Witberg Wind Energy Facility and associated infrastructure, Western Cape Province

Final Motivation for amendment of Environmental Authorisation

DEA Ref.: 12/12/20/1966/AM7

April 2019

Figure 7.1: Final Updated Layout for the Proposed Amendment
 Motivation Report

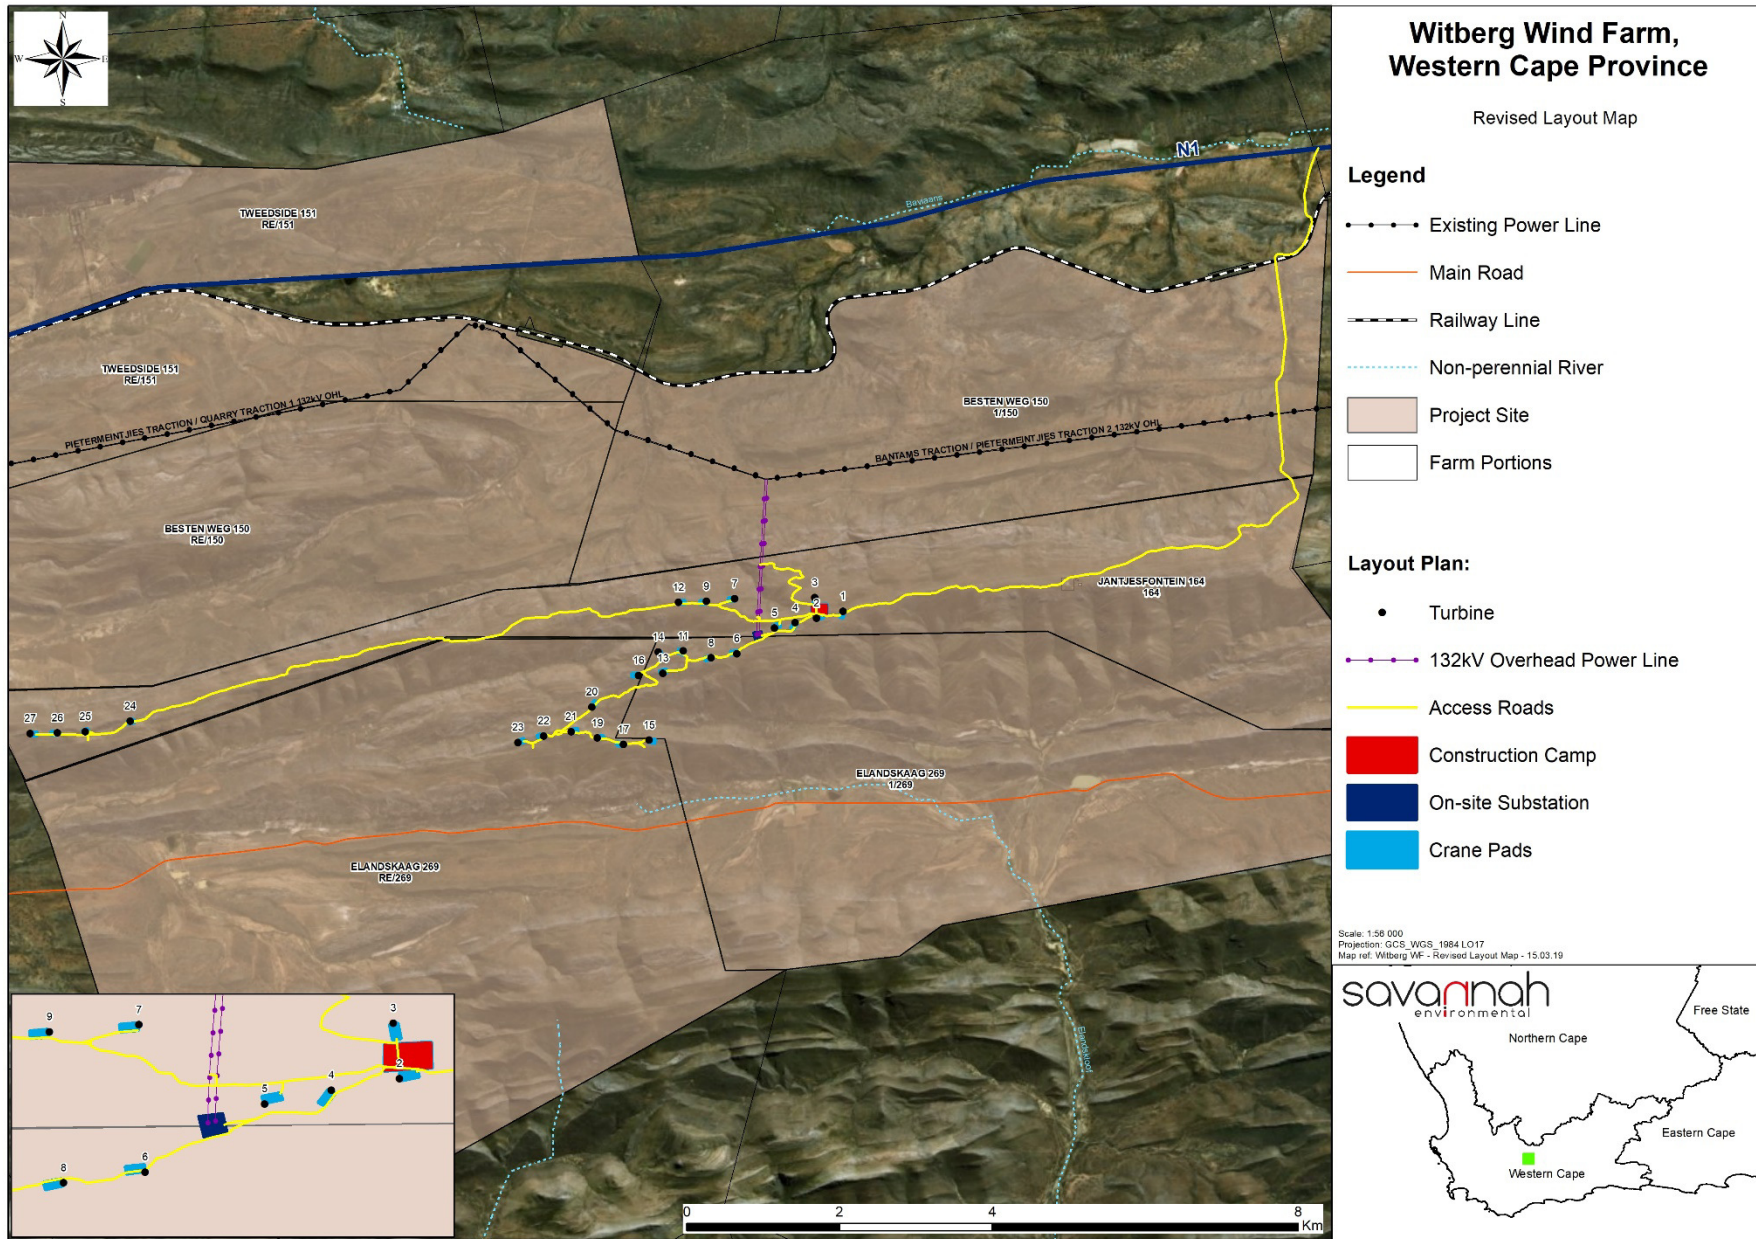
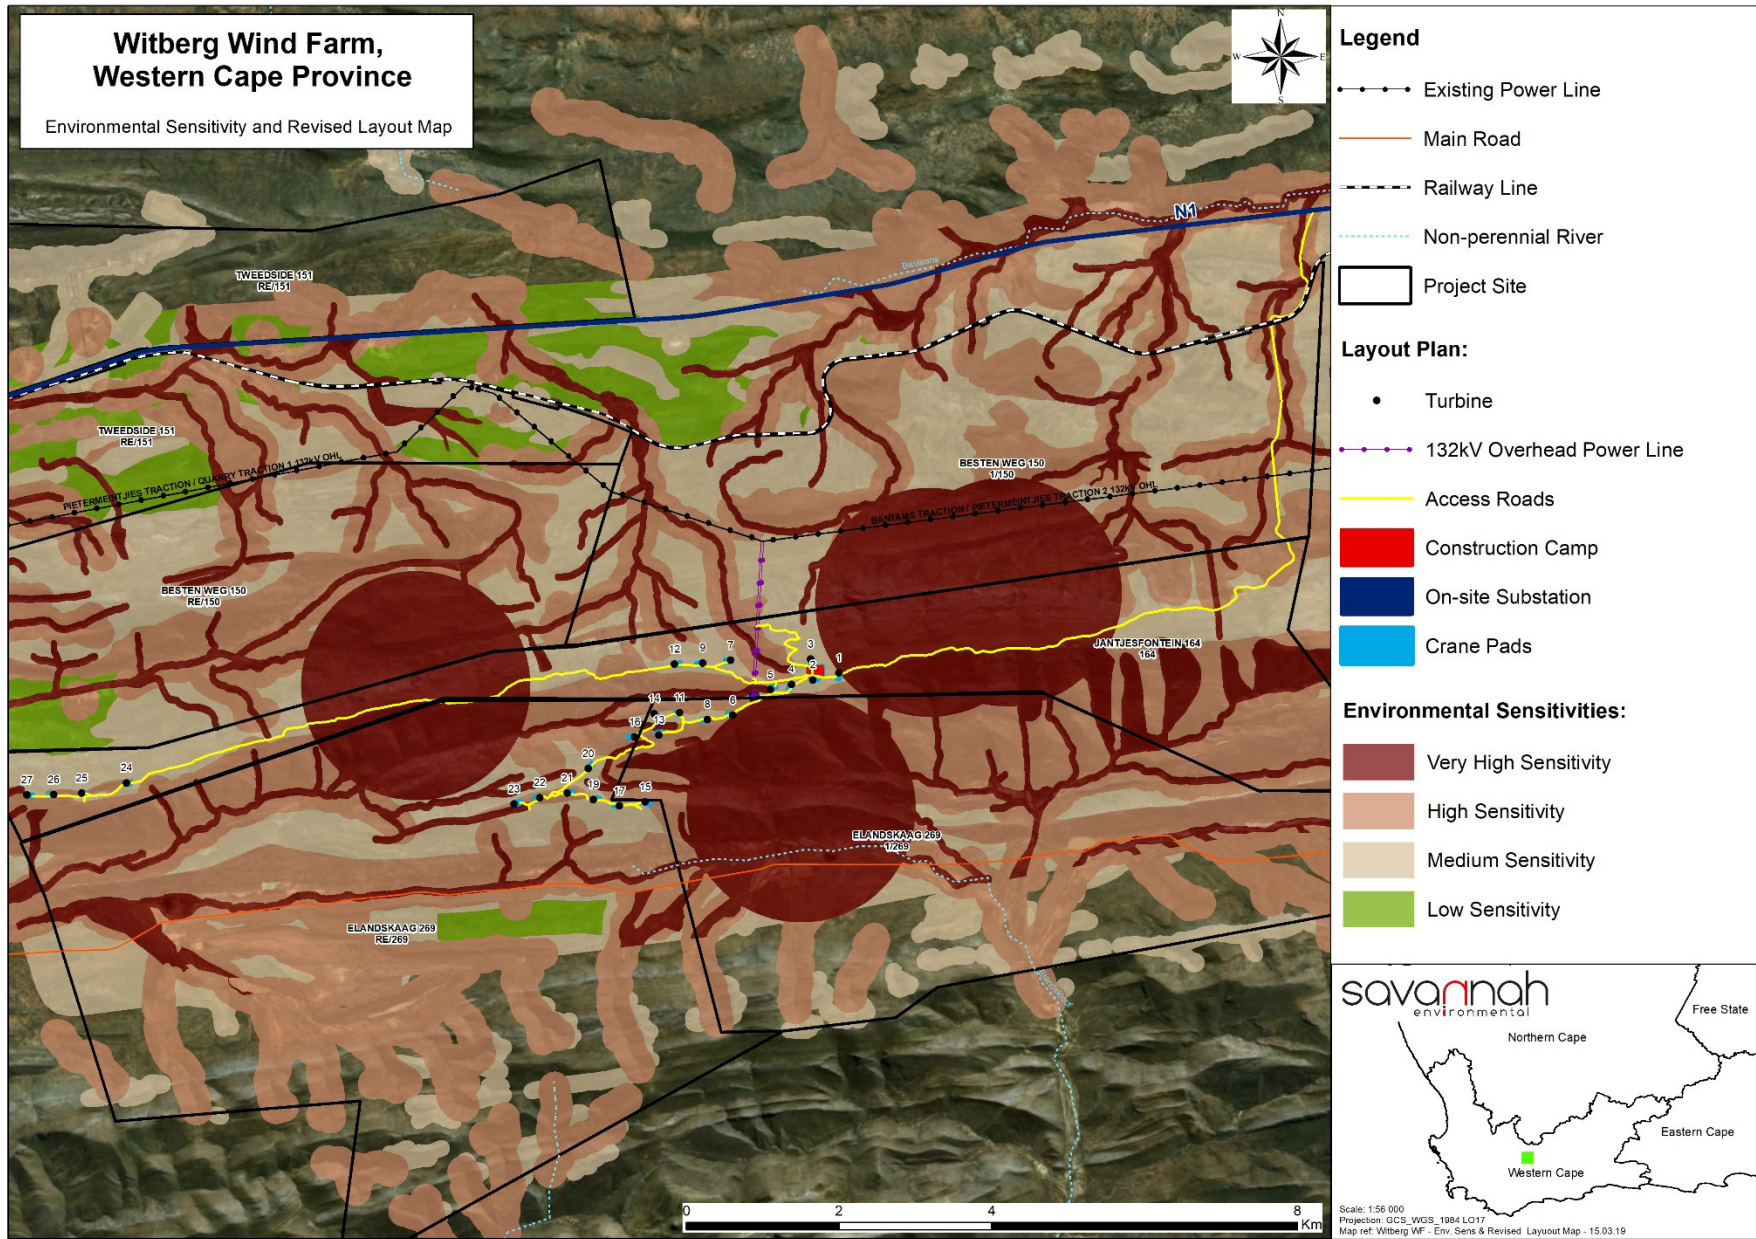
DEA Ref	Comments from DEA on the initial Motivation Report	Report Reference and Response from EAP
	<p>substation, the main substation and internal powerlines.</p> <ul style="list-style-type: none"> • All existing infrastructure on the site, especially internal roads infrastructure. • The location of sensitive environmental features on site e.g. CBAs, heritage sites, wetlands, drainage lines etc. that will be affected by the facility and its associated infrastructure. • Buffer areas. • All "no-go" areas. 	
(c)(iv)	<p>The final report must include an environmental sensitivity map indicating environmental sensitive areas and features identified during the assessment process.</p>	<p>Refer to Figure 7.1 and Figure 7.2 of the Revised Motivation Report.</p>
(c)(v)	<p>The final report must include a map combining the final layout map superimposed (overlain) on the environmental sensitivity map.</p>	<p>Refer to Figure 7.1 and Figure 7.2 of the Revised Motivation Report.</p>

The additional relocation of the above components is shown in **Figure 7.1** below. The associated environmental sensitivities overlaid by the proposed layout is shown in **Figure 7.2** below. The proposed layouts below are the final proposal layout for consideration in this amendment application.
